Alternative modeling scenarios and other considerations for Virginia Electric and Power Company's 2024 Integrated Resource Plan

Joshua D. Rhodes, PhD & Nicholas D. Laws, PhD

February 2025

Figure 1: Comparison of GenX and IRP PLEXOS results for model validation (case: VCEA WITHOUT EPA). Total builds by technology and total capacity purchases by 2039 for both GenX and PLEXOS modeling. Capacity purchases are shown as the average annual capacity purchases from 2025–2039.

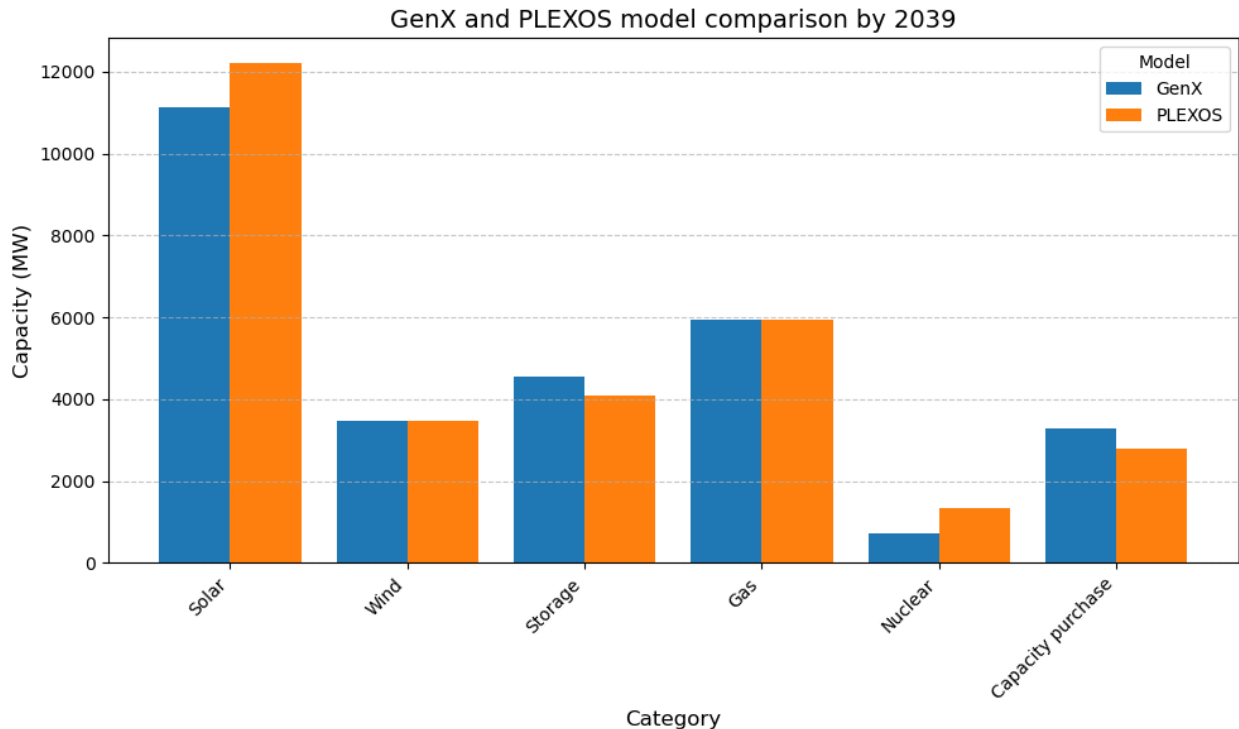
To validate the GenX model and create a baseline to perform sensitivities for this report, we recreated the IRP PLEXOS results from the data Dominion provided in discovery. We chose the “VCEA WITHOUT EPA” IRP scenario as the starting point for sensitivities, which allows addition of components such as the EPA requirements to demonstrate their impact on the model results. Figure 1 shows a comparison of the GenX model results and the IRP PLEXOS results.

Figure 2: Capacities installed in 2039 compared across the VCEA WITHOUT EPA, VCEA WITH EPA RGGI, VCEA WITH EPA RGGI NEM6, VCEA WITH EPA RGGI NEM8, and VCEA WITH EPA RGGI DOUBLE CLEAN scenarios.

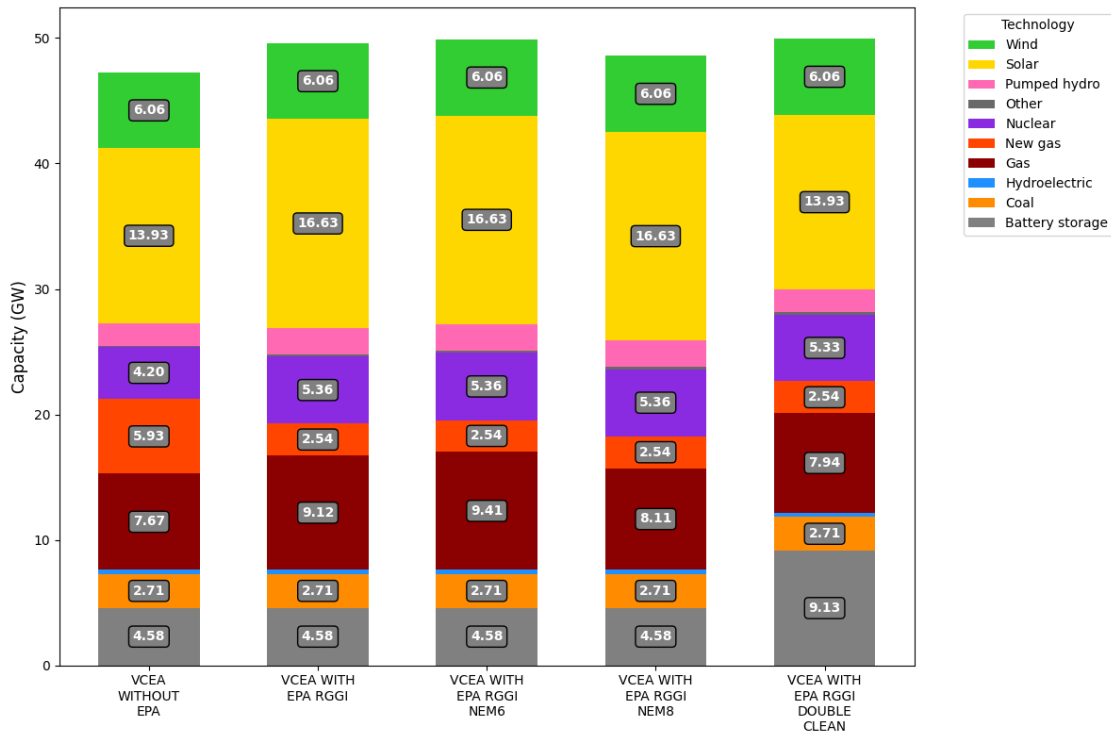
Figure 2 shows the final installed capacities by technology and scenario in 2039. Many of the trends enumerated above can be drawn from Figure 2. For example, 4.58 GW of storage is installed in all scenarios except the DOUBLE CLEAN scenario,¹¹ which has twice the amount of storage installed at 9.13 GW (values rounded). In all scenarios, 2.54 MW of new gas is installed except for the VCEA WITHOUT EPA scenario (the IRP validation scenario utilizing Dominion’s assumptions), which installs 5.93 MW.

Figure 3: Total present costs of all 2039 scenarios. “RECs” is Renewable Energy Certificates.

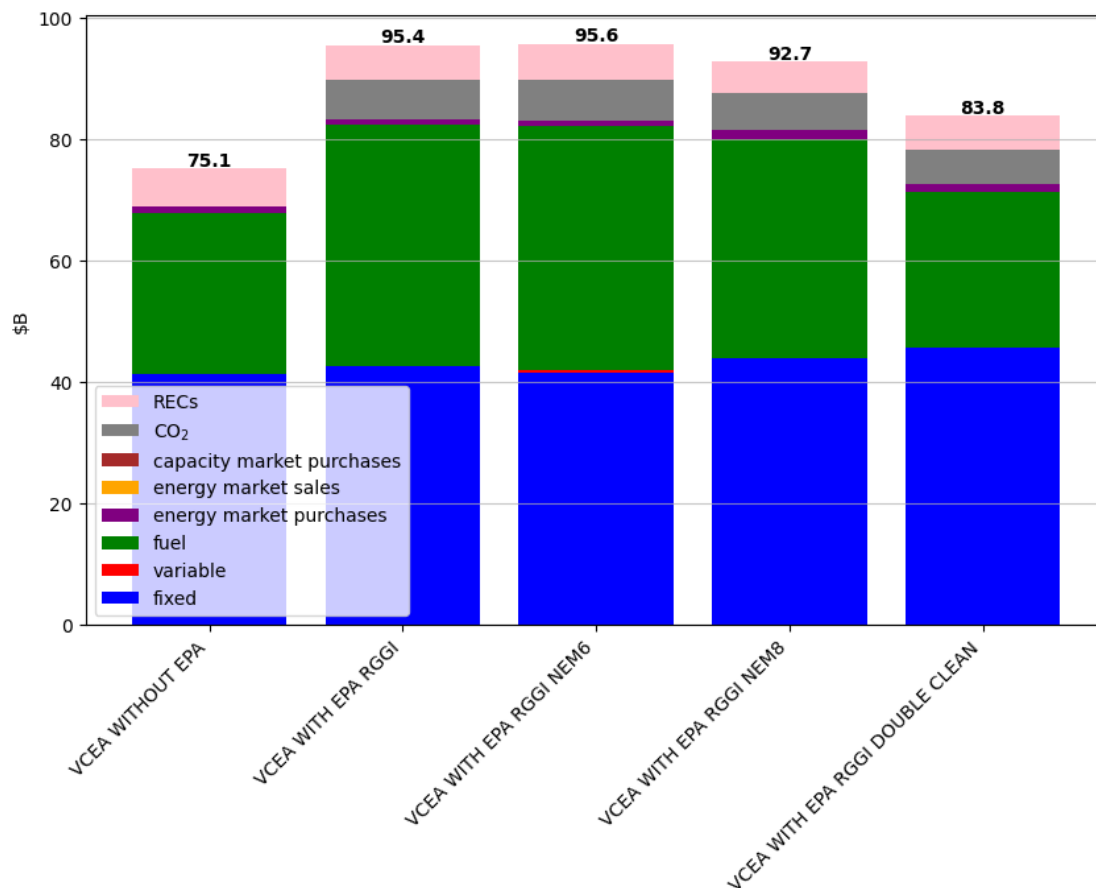
Figure 3 shows that the lion’s share of costs in all scenarios are the fixed (including capital costs) and fuel costs, followed by CO₂. The energy and capacity market transactions are relatively small compared to the other costs. Note that the total costs in our 2039 scenarios align well with the “Total System Costs” of the Primary Portfolios presented in the DOM IRP Table 5.2.2, which range from \$72.1B to \$81.3B.¹²

The VCEA WITHOUT EPA scenario appears to have the lowest cost by retiring more, less efficient gas generators and buying newer, more efficient gas generators at higher capacity factors, which results in the purchase of less nuclear power than other scenarios. However, the fact that the model sees it as economic to build new gas resources 10–15 years before they must retire (based on the 2045 zero-carbon requirement) provides a direct example of the limitations of this planning horizon. While this portfolio appears as the lowest cost of the 2039 portfolios, it also contains the greatest amount of counterproductive investments for efficiently meeting the 2045 zero-carbon requirement. In fact, and as discussed in **Section: Quantitative Analysis with 2045 Horizon**, using the assumptions in VCEA WITH EPA RGGI but modeling out to 2045, we found the build limits to be too restrictive to find a solution that fulfills the capacity needs or the 2045 zero-carbon requirement.

Figure 4: Total present fuel costs of all 2039 scenarios.

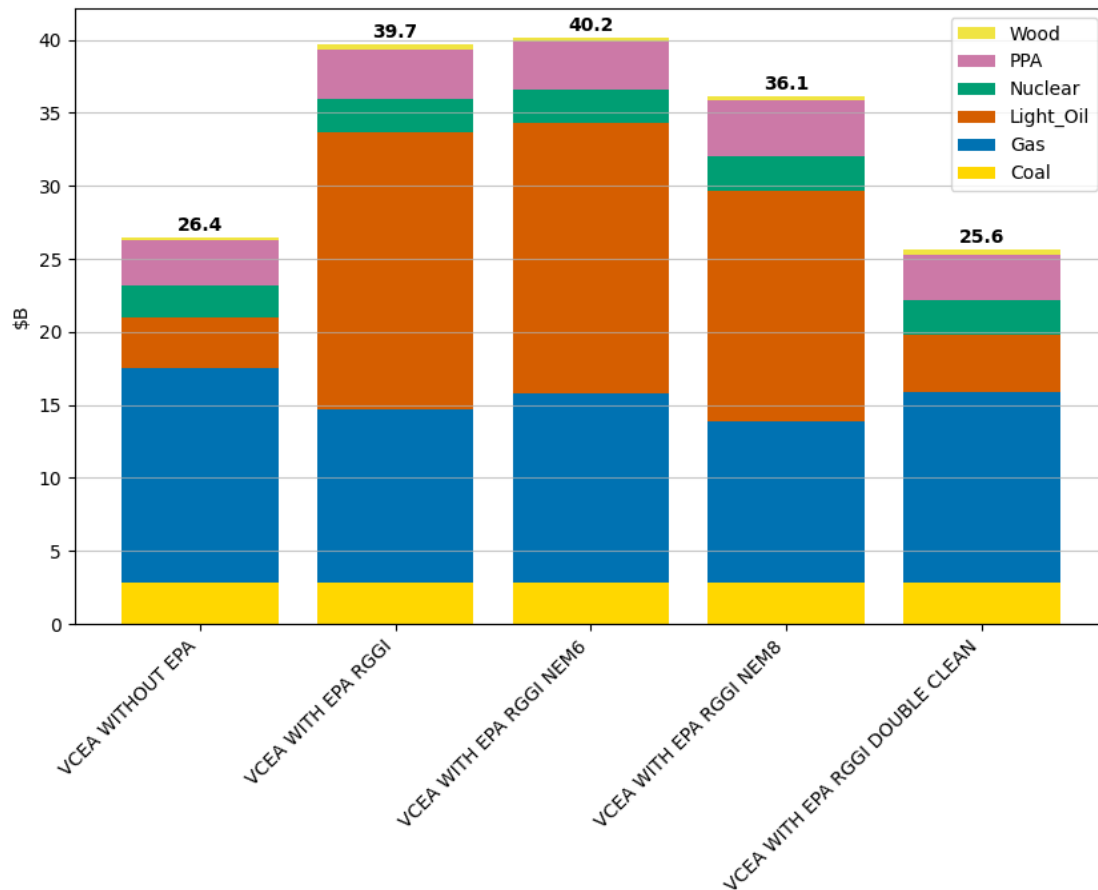
Figure 4 breaks down the fuel costs shown in the total costs chart by fuel type.

- The DOUBLE CLEAN scenario has lower fuel costs relative to the other 2039 scenarios primarily by installing the maximum amount of energy storage available—without requiring the maximum amount of solar and wind resources. These trends are visible in Figure 4 and Figure 7.

Figure 5: Annual CO₂ emissions from 2024–2039 for scenarios: VCEA WITH EPA RGGI, VCEA WITHOUT EPA, and VCEA WITH EPA RGGI DOUBLE CLEAN.

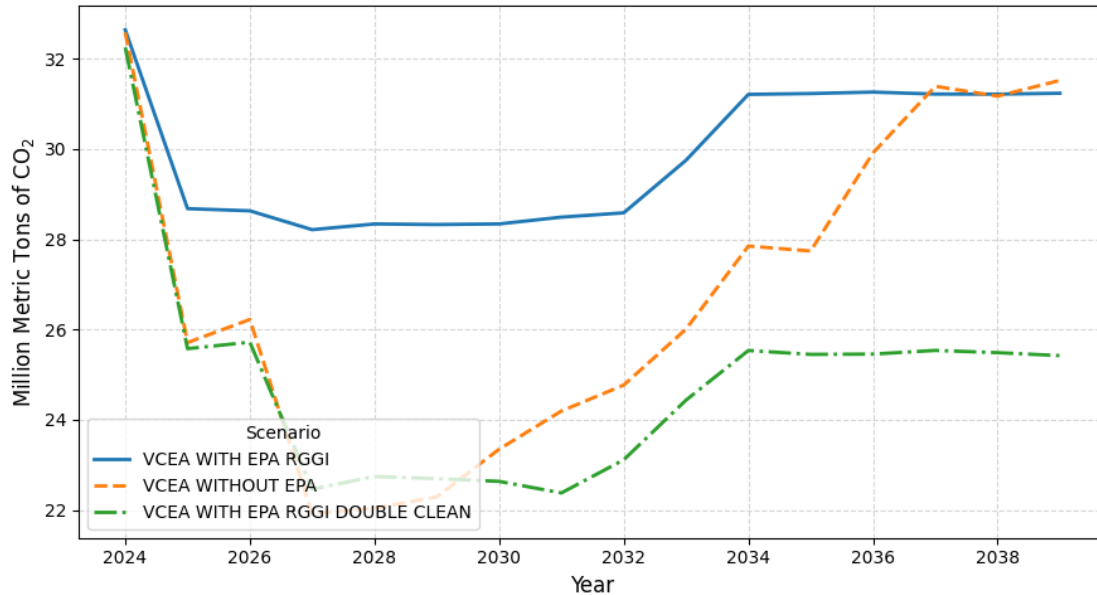
Figure 5 shows the annual CO₂ emissions across several scenarios including the VCEA WITHOUT EPA scenario. While it's interesting to note that the VCEA WITHOUT EPA scenario achieves relatively lower emissions in middle years from retiring gas generators, the annual emissions rise back up to 2025 levels in later years with the addition of new gas generators.

Figure 6: Capacity changes by type of power plant per year for the VCEA WITH EPA RGGI DOUBLE CLEAN scenario.

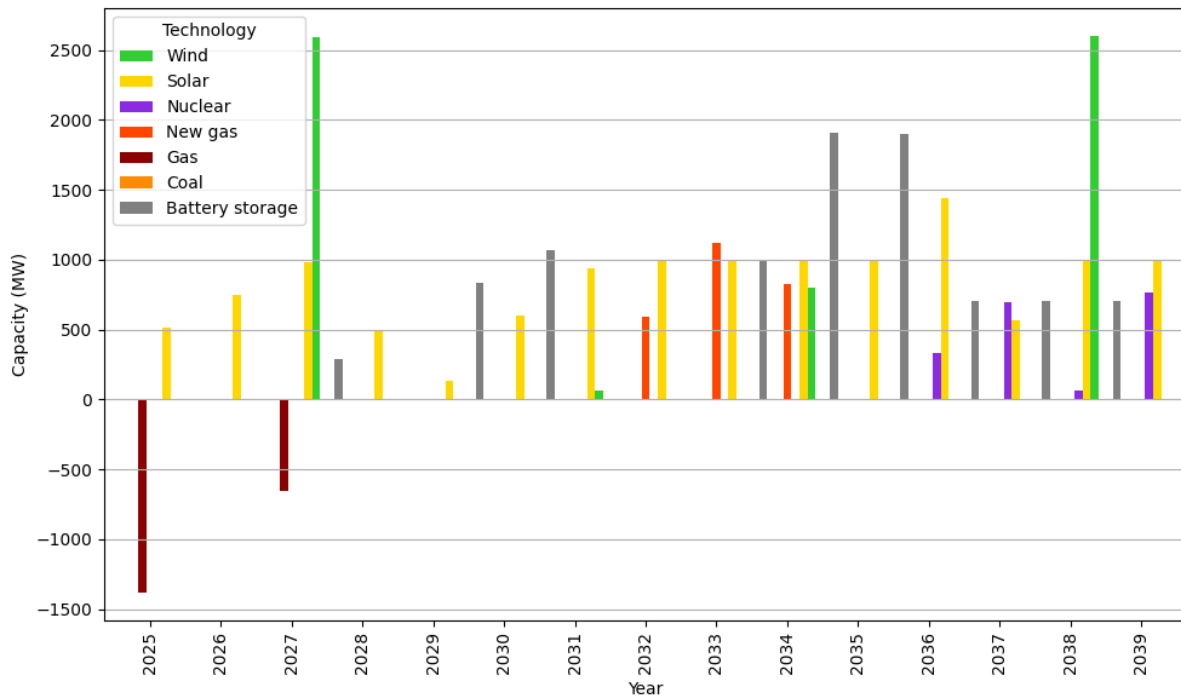
- The DOUBLE CLEAN scenario chooses to build more than 2 GW of new storage *before* building any new gas, as shown in Figure 6. This result suggests that investing in storage earlier could displace or put off any short-term gas needs, providing Dominion and the Commission time to develop more clarity for the current load growth uncertainty as well as more time to better understand emerging technologies, like long duration storage and nuclear, that will not become stranded assets in 2045.

Figure 8: Existing and new nuclear capacity trends 2024–2039 for VCEA WITHOUT EPA and VCEA WITH EPA RGGI DOUBLE CLEAN scenarios.

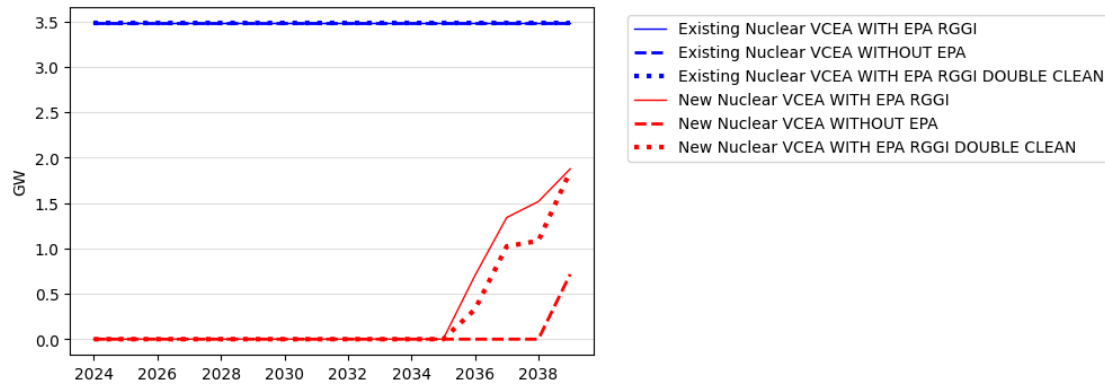
Similar amounts of nuclear generation are purchased in the VCEA WITH EPA RGGI and DOUBLE CLEAN scenarios, even though the DOUBLE CLEAN scenario can install twice as much capacity, as shown in Figure 8. We can also see that less nuclear is installed without the EPA Rule 111(b) capacity factor limit on gas generators.

Figure 9: CO₂ intensity trends 2024–2039 for all 2039 scenarios.

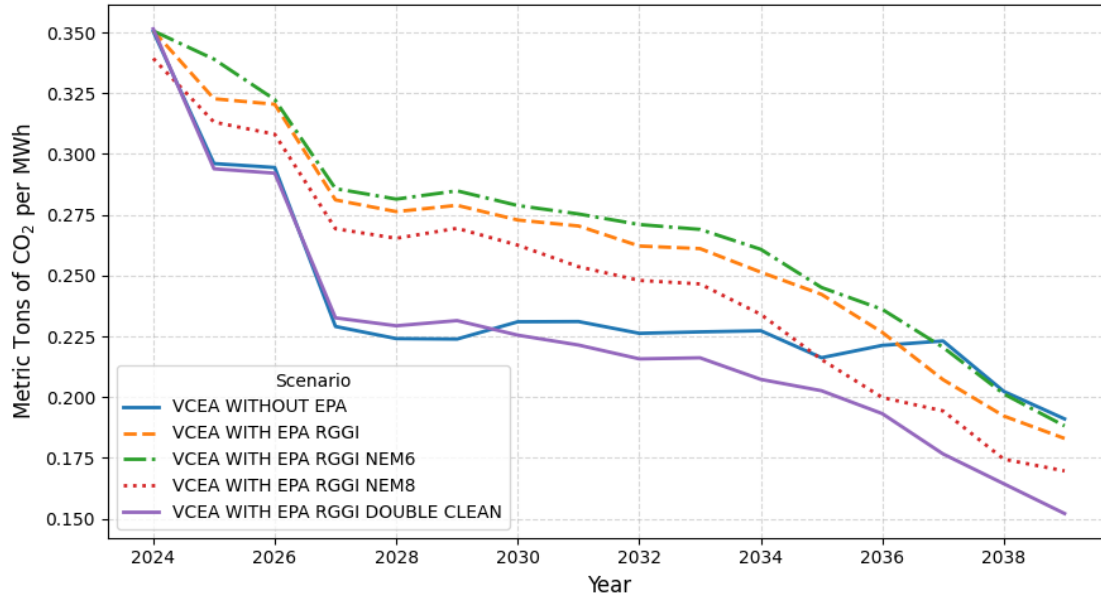
Figure 9 and Figure 10 show the CO₂ emission intensity and annual emissions trends, respectively, for all the 2039 scenarios. As expected, the DOUBLE CLEAN scenario achieves some of the lowest emissions almost every year in both metrics.

Figure 10: Annual CO₂ emissions trends 2024–2039 for all 2039 scenarios.

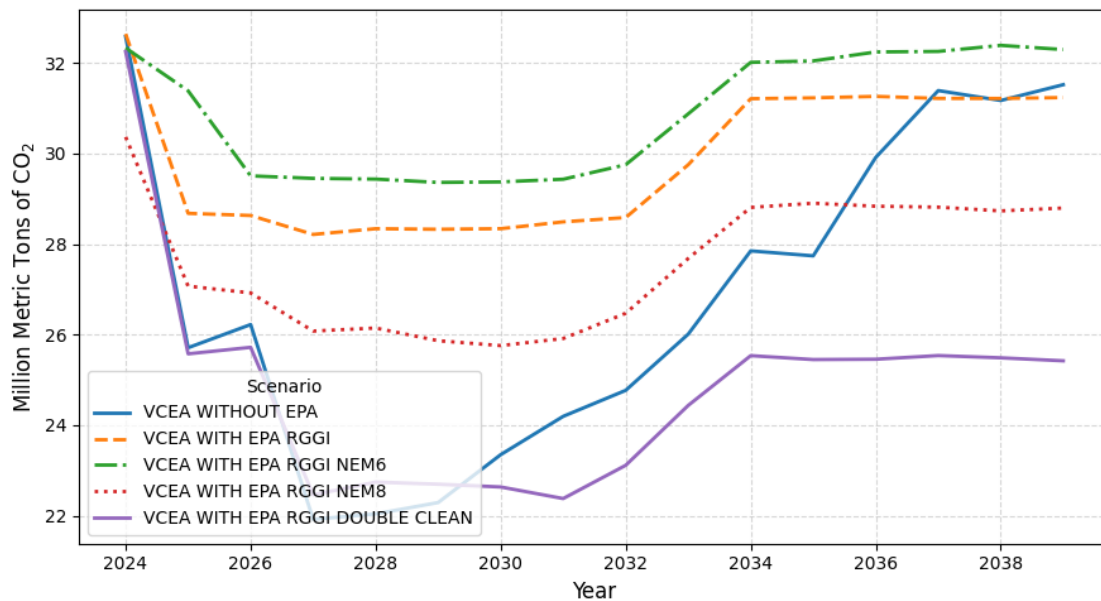
The trend of dropping annual emissions in earlier years and rising annual emissions in later years in Figure 10 is explained by the gas generation capacity trends shown in **Section: Gas Resource Trends in 2039 Scenarios**, where some existing gas generation is retired in early years and new capacity is installed in later years. This finding illustrates yet another reason why the Commission should require Dominion to extend the planning horizon to 2045. Otherwise—even under the cleanest scenarios—the model will install resources that keep CO₂ emissions elevated over the long term.

Figure 11: Gas capacity trends 2024–2039 in VCEA WITH EPA, VCEA WITHOUT EPA, and VCEA WITH EPA RGGI scenarios, broken down by existing and new installations.

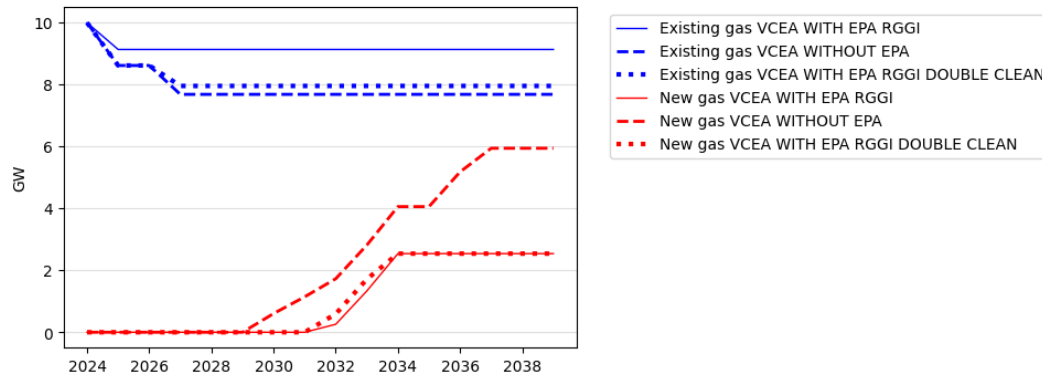
The trends in gas resource capacities for existing and new generators are shown in Figure 11 and Figure 12. Figure 11 highlights the additional gas generation that is installed when the 40% capacity factor limit on gas resources is removed in the VCEA WITHOUT EPA scenario. Otherwise, the three figures all show that the 2,536 MW of new CC gas generation is built by 2037 or sooner, and that roughly 1–3 GW of existing gas generation is retired in the first four years.

Figure 12: Gas capacity trends 2024–2039 in VCEA WITH EPA RGGI NEM6 and VCEA WITH EPA RGGI NEM8 scenarios, broken down by existing and new installations.

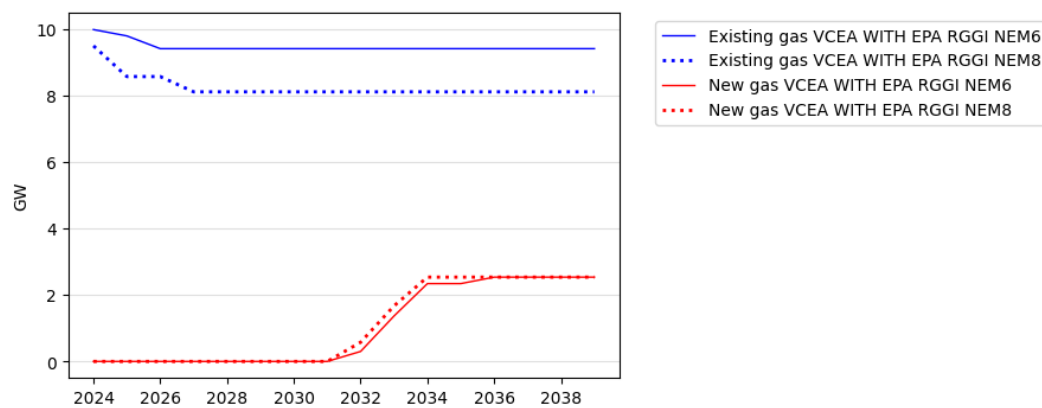
When comparing the NEM scenarios in Figure 12, the NEM6 scenario keeps more existing gas generation than the NEM8 scenario. The additional gas generation in the NEM6 scenario is also visible in the emission charts in **Section CO2 Emission Trends 2024–2039**.

Figure 13: Annual CO₂ emissions trends 2024–2045 for all 2045 scenarios.

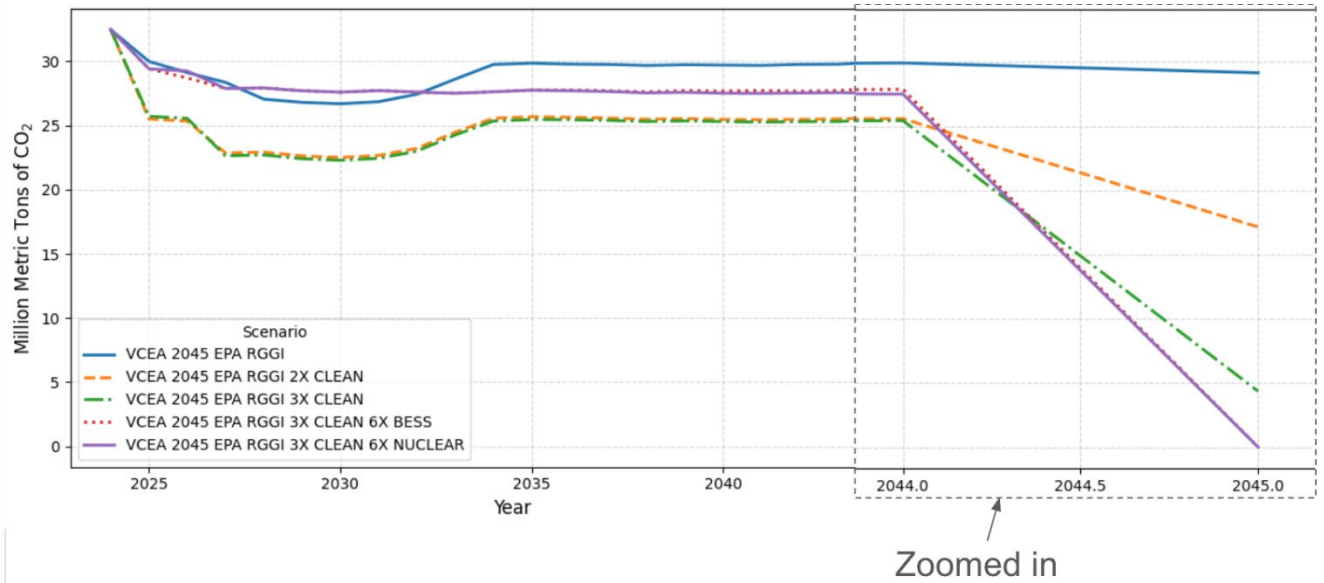
As Figure 13 shows, the VCEA 2045 EPA RGGI scenario cannot meet the zero-carbon requirement. (It also has a capacity reserve shortfall in 2045). Thus, we raised the limits on clean energy resources to find solutions that could meet the zero-carbon requirement. When increasing the clean energy resources available to build by two and three times, the model continues to fall short of the zero-carbon requirement at ~17.5 and ~5 million metric tons of CO₂ emissions by 2045, respectively, and at similar costs to the 2045 baseline scenario (see Figure 20). Contrast these CO₂ numbers to the baseline scenario (using extended IRP values), which emits ~29 million metric tons of CO₂ in 2045. To identify VCEA-compliant solutions, we further increased the amount of storage and nuclear capacity available to the model by six times.

The annual emissions for the 2045 scenarios are shown in Figure 13, which shows that the zero-carbon requirement can be met only when the limits on storage (BESS) or nuclear (SMR) resources are significantly raised relative to the IRP. Figure 14 shows the carbon intensity for the 2045 EPA RGGI scenario and the two scenarios that do meet the zero-carbon requirement. Here we can see that the scenario with more nuclear achieves the lowest annual carbon intensity values starting in about 2035.

Figure 15: Comparison of installed storage capacity vs. the capacity limits between two 2045 scenarios. Both scenarios install the maximum amount of energy storage. Note the different vertical scales between subfigures (a) and (b).

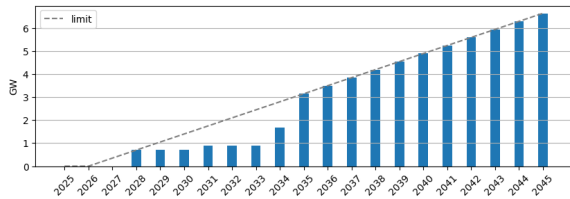
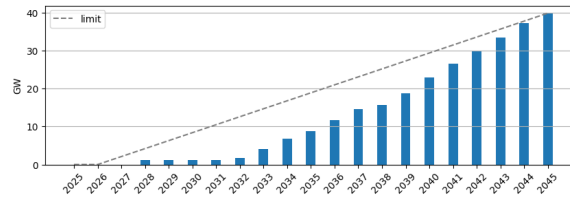
All of the 2045 scenarios install the maximum amount of storage available by the end of the model horizon. Figure 15 shows the cumulative new storage capacity in two 2045 scenarios to highlight this point.

Figure 16: Cumulative new solar capacity over time in two 2045 scenarios that meet the zero-carbon requirement. Both scenarios build a total of ~12 GW of solar by 2045.

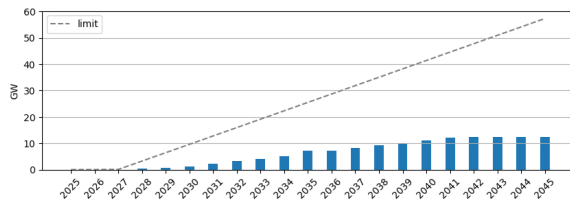
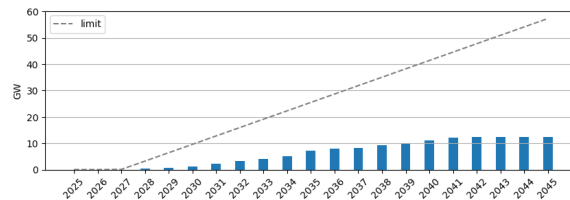
The 2X CLEAN and 3X CLEAN scenarios install the maximum amount of solar (~37 and ~56 GW respectively) in 2045 without meeting the zero-carbon requirement. However, when either more storage or more nuclear resources are available to meet the zero-carbon requirement, just 12 GW of new solar is sufficient to meet the zero-carbon requirement, as shown in Figure 16.
